UPDATE Technical Bulletin

UPDATE – 97AO Fuse Box Washers (NVLW)

Model(s)	Year	Engine Code	Trans. Code
Passat	2013-2014	All	All

Production Solution

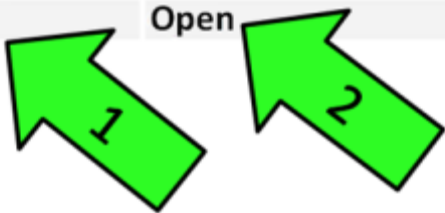
As a result of the fuse box weld pin length used during production, the fuse box wiring harness could come in contact with the fuse box weld pins.

Implemented in production calendar week 32 of 2013.

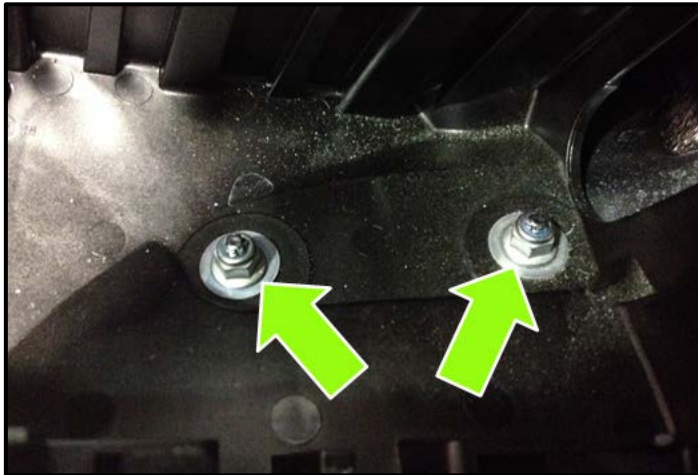
Tip: Using a permanent marker, label the position of the connections as shown <circle> so that they are installed correctly during reassembly.

- ⇐ Loosen and remove the threaded connections <circle> on the E-box.

- ⇐ Release the tabs <arrows> while gently lifting the e-box upward out of the housing.

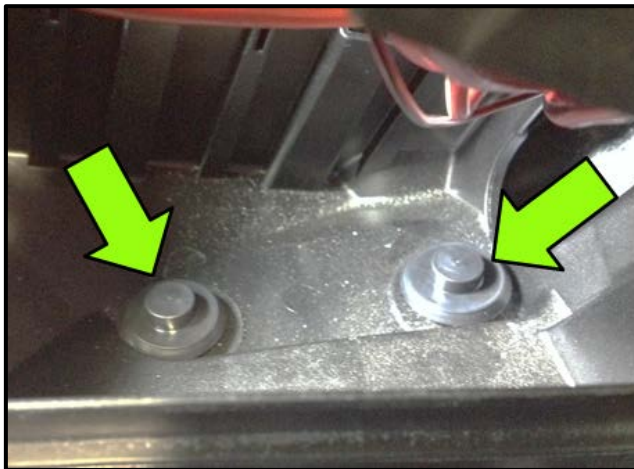
⇐ Remove the two nuts <arrows>.

⇐ Place 1 washer part number (N 011 666 20) onto each mounting stud, then reinstall the nut onto the mounting stud.

- Torque each nut to 6Nm.

Note: It is not necessary to remove the existing washers from the mounting studs. Simply install the replacement washers over top, then reinstall each nut.
